CIRCULATE TO:	SERVICE MGR.	PARTS MGR.	MECHANICS	Place in Your "Service Bulletins" Binder
---------------	--------------	------------	-----------	--

- A. Shift Inter-lock Adjustment * Merc 500M and 402M
- B. "Sealed" Batteries
- C. Recommended RPM * Merc 1750
- D. Flushing and Test Tank Operation * 1976 Merc 1500XS and 850XS

Figure 1. Cable Adjustment

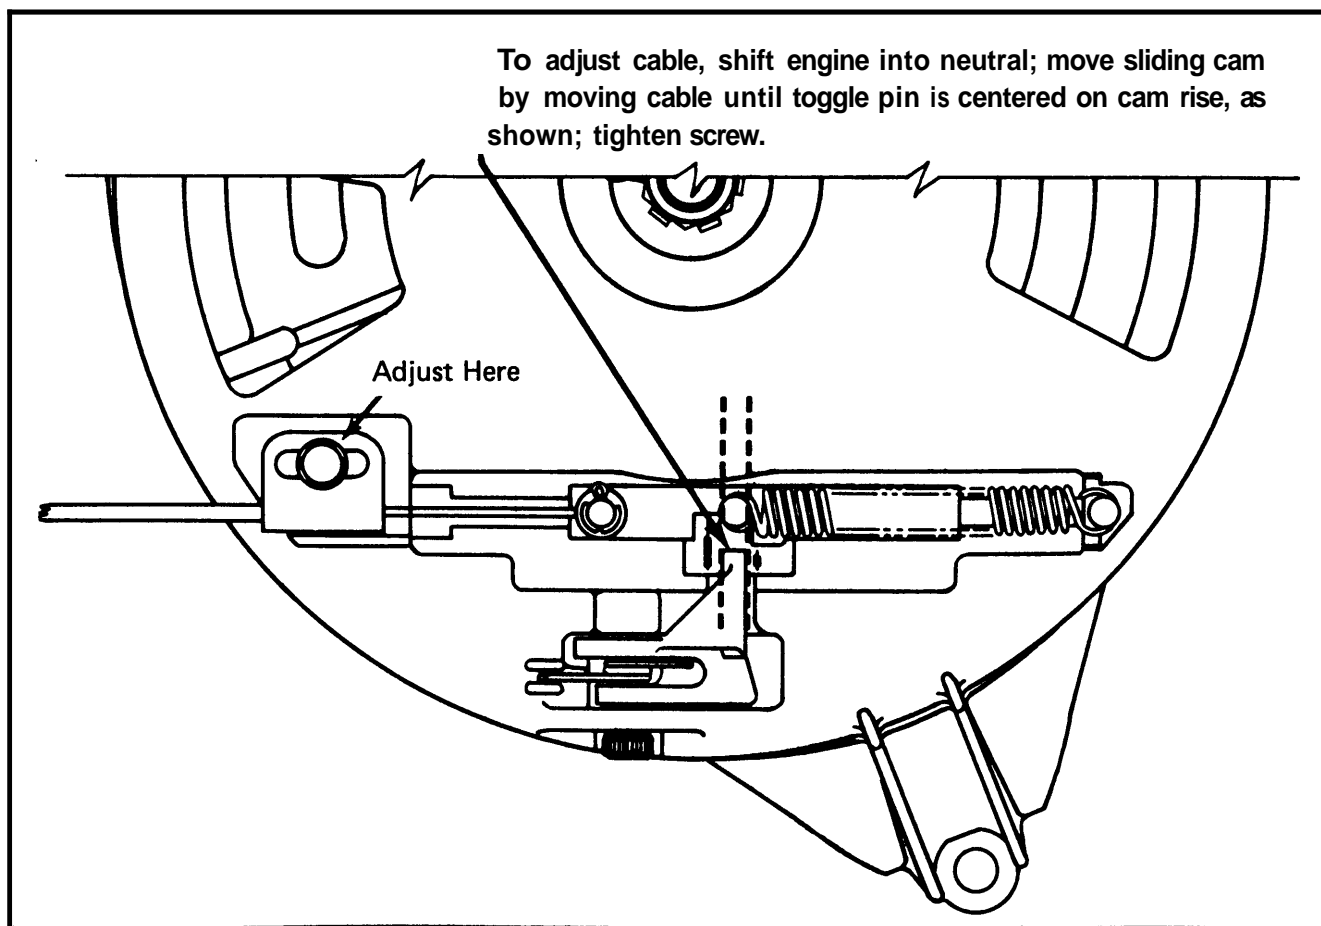
Merc 500M and 402M incorporate a shift inter-lock which allows the rewind starter to operate in neutral position only. Installation of a remote control assembly or an auxiliary steering handle, therefore, requires shift inter-lock adjustment.

After installing the shift cable (shift rod on auxiliary handle) and before throttle cable installation, remove the top cowl and adjust the shift inter-lock as shown in Figure 1.
